MCPB

809 Easley Street, Preliminary Plan No. 120200010

Preliminary Plan No. 120200010

Figure 8 – Modified Silver Spring Streetscape along Easley Street

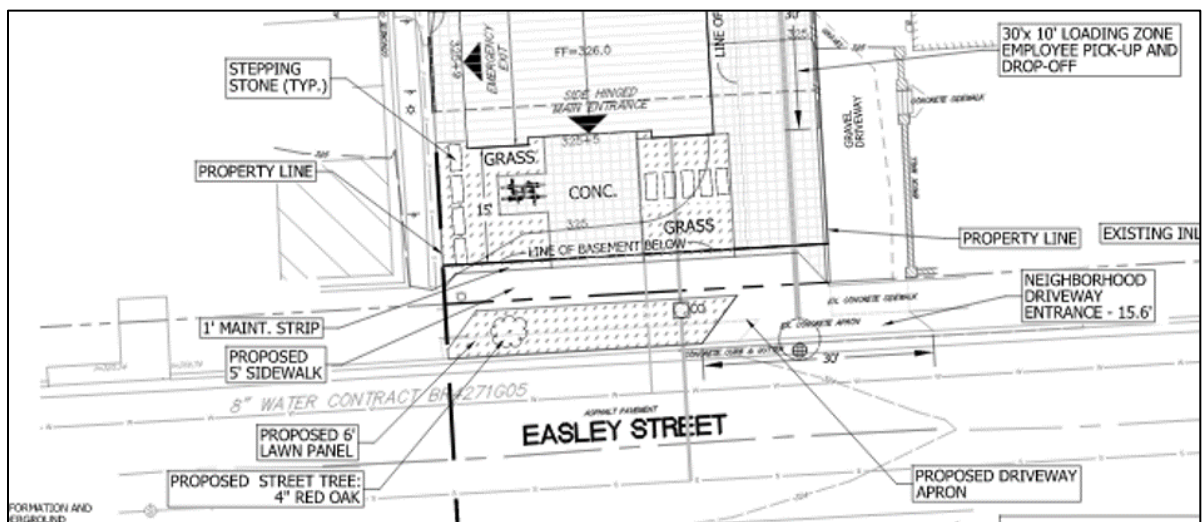
The Project will provide a modified Silver Spring Streetscape Standard along the Property's Easley Street frontage, within the dedicated right-of-way. The modifications are necessary to provide an accessible transition from the existing sidewalk immediately to the west of the Site, in front of the MCDOT public parking lot and have been endorsed by both Planning Staff and MCDOT. The sidewalk in front of the MCDOT parking lot is 10 feet wide and immediately abuts the street without a buffer or a tree panel. A fence along the eastern side of the parking lot district vertically separates the Site from the adjacent public parking lot, and MCDOT has no plans to remove or modify the fence. On the east side of the Site, is a four-foot sidewalk with a two-and-one-half-foot grass buffer. Redevelopment of the MCDOT parking lot to the west of the site and the adjacent residential property to the east of the site is unlikely in the near term. Furthermore, the boundary of the Silver Spring Streetscape Standards is congruent with the eastern Site property line and therefore all lots to the east of the Site will not be held to the same design standard. Therefore, to maintain a comfortable and accessible pedestrian pathway along the entire northern side of 809 Easley Street, the modified streetscape, depicted in Figure 8, moves the existing sidewalk back three and one-half feet, and is widened to five feet. The existing two-and-one-half-foot buffer will be widened to six feet. Staff supports deviation from the standard streetscape to achieve the intent of the Streetscape design standards which is to provide an accessible travel zone for pedestrians of all abilities.

FIRE DEPARTMENT ACCESS PLAN

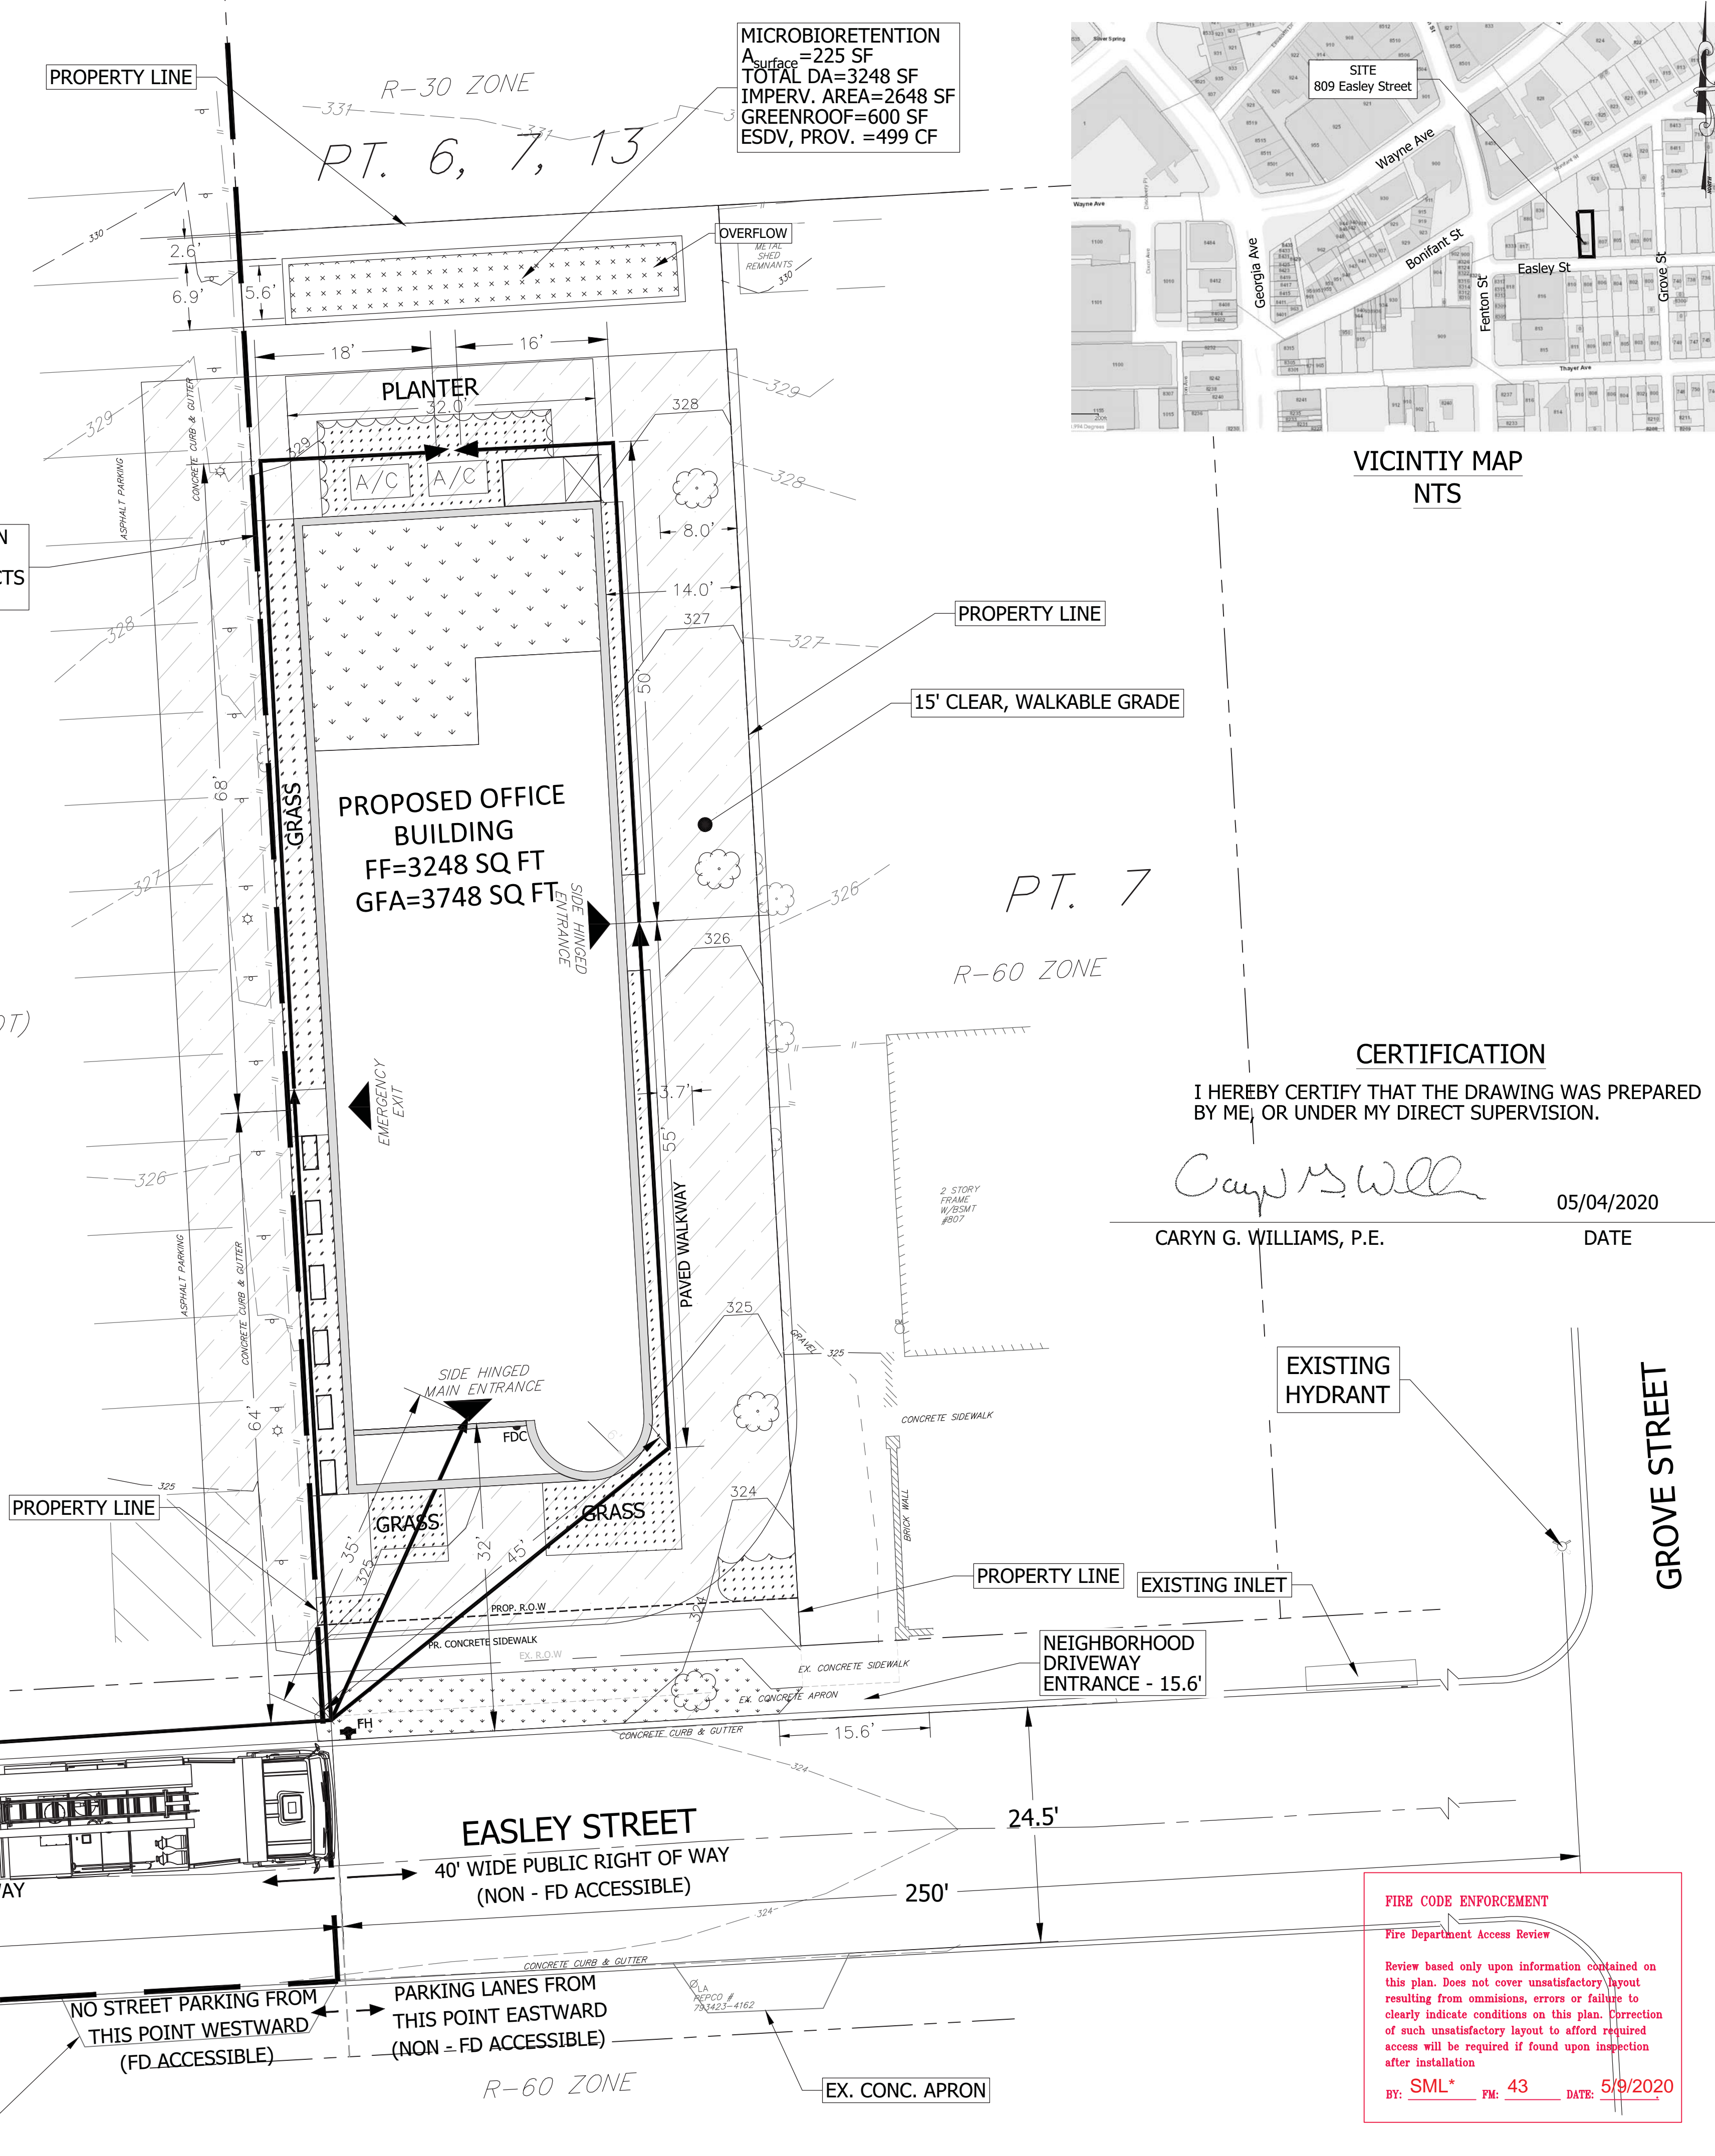
All buildings, parts of buildings, or other obstructions extending over access driveways shall have not less than 12 feet vertical clearance from the finished driveway surface.		X
Where approved fire protection systems are provided, the above required clearances may be modified or waived.		X
When any portion of the first story of any building is more than 300 feet from a public street, or access way, one of the following shall be provided: -The entire building shall be protected with an automatic fire extinguishing system, or -The building shall be made accessible for fire motor vehicle apparatus by an all-weather access way approved by the director.		X
